29 January 2026

Waitākere District Court, New Courthouse Project: Transport-Related Comments from Panel

This memorandum has been prepared to address the matters raised in the comments to the Expert Consenting Panel with regard to transportation matters associated with the above project. For ease of reference, we have initially set out the matter raised (in some cases, this has been paraphrased or summarised)

Figure 1: Legal Extent of Right-of-Way (Extract from Architectus Drawing, Annotated)

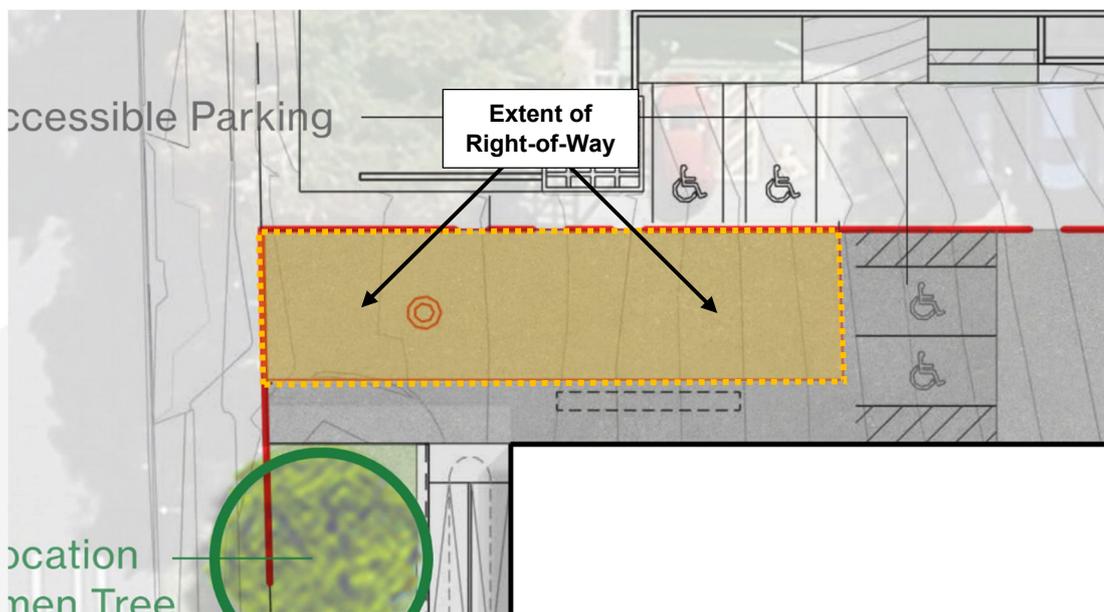
Tracking for entry manoeuvres at The Alderman as well as exit manoeuvres

As set out in the application, The Alderman is served via a right-of-way off Alderman Drive. Based on the information provided, the extent of the legal right-of-way is as set out Figure 1 below.

It is not proposed to make any revisions to the formed layout of this existing vehicle crossing as part of the Notice of Requirement application. As such, there will be no changes to the current vehicle manoeuvring with regard to entry movements arising from the proposed designation.

Figure 3: 6.4m Truck (AS2890.2) Reversing into Mobility Spaces

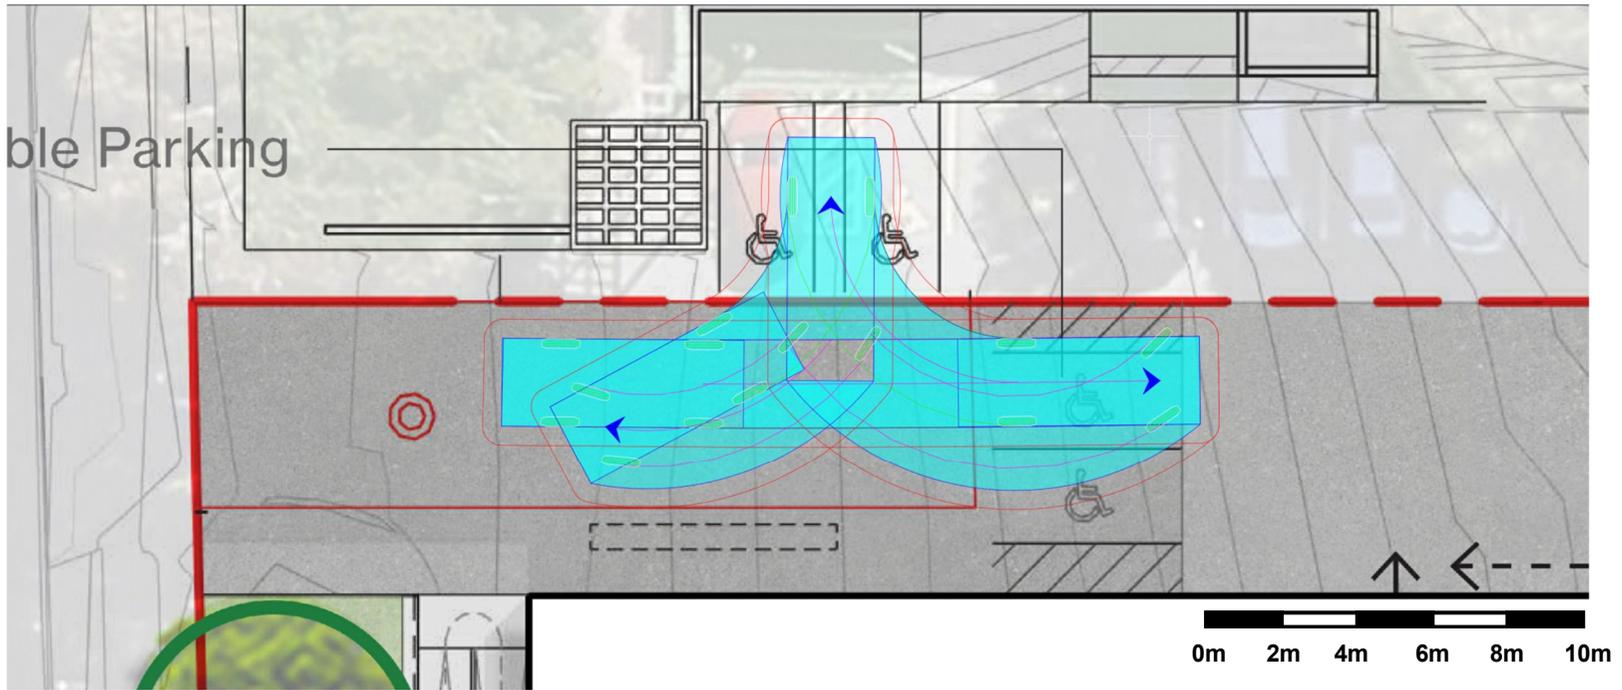
Vehicle tracking assessment for a waste collection or servicing vehicle at The Alderman

The existing right-of-way is only 5.4m wide, which is not sufficient for an 8m rigid truck to enter and turn. On the attached Figures 4 and 5, we demonstrate how tracking for a 6.4m long rigid vehicle (as specified in the Australian Standard¹ AS2890.2:2018 (*Parking Facilities Part 2: Off-Street Commercial Vehicle Facilities*)) is achieved.

In these Figures, the cyan line is the area occupied by the vehicle bodywork and the thin red line is a clearance of 500mm around the bodywork to allow for minor protrusions (such as wing mirrors) and for a 'margin of error' if the driver takes a slightly different route to the ones shown (we note that the clearance is greater than for a car).

Figure 4 shows the tracking for a truck utilising the existing accessible parking spaces at The Alderman (which are accessed via the right of way easement), and Figure 5 demonstrates the tracking for a truck that utilises the marked 'no-parking' area at The Alderman (which is outside the right of way easement). The tracking diagrams provided demonstrate the existing lawful arrangement does not provide for a 6.4m truck to manoeuvre within the legal extent of the right of way, which is reflective of the current arrangement on the site.

Figure 5: Two B99 Cars Passing at Southeastern Site Access

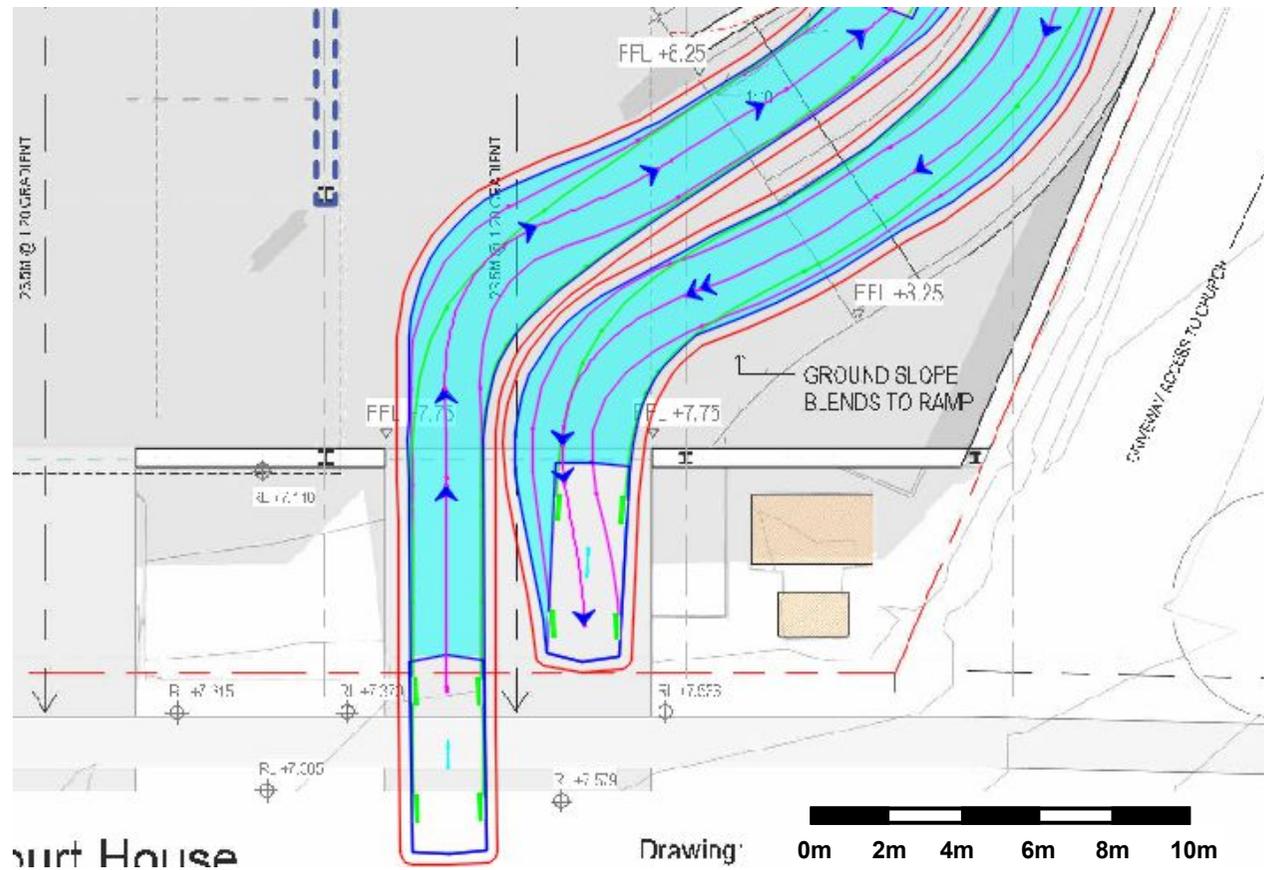
Scaled plans should be provided to support the case for a vehicle crossing width of 7 metres or more (being in excess of the maximum 6 metre width permitted by the Unitary Plan Transport Chapter)

Enlarged scaled plans should be provided which show internal layouts, site infrastructure and tracking paths more clearly

The drawings show one location where a width of more than 6m is provided, which lies to the southeast of the site. Tracking curves are shown in the attached Figures 5 and 6 for this. As noted above, the cyan line represents the vehicle bodywork and the thin red line is a clearance of 300mm or 500mm (for cars and trucks respectively) from the bodywork.

Although some detail is shown on Figures 5 and 6 (as the need for a 7m wide vehicle crossing is influenced by the internal layout), the application is for a designation and as such there is no confirmed internal layout at this time. Rather, matters of future design are controlled through proposed conditions on the designation which provide for a certainty of outcome without a detailed layout being currently available. Any tracking could therefore only be indicative and would potentially be subject to change, and so it has not been provided at this time.
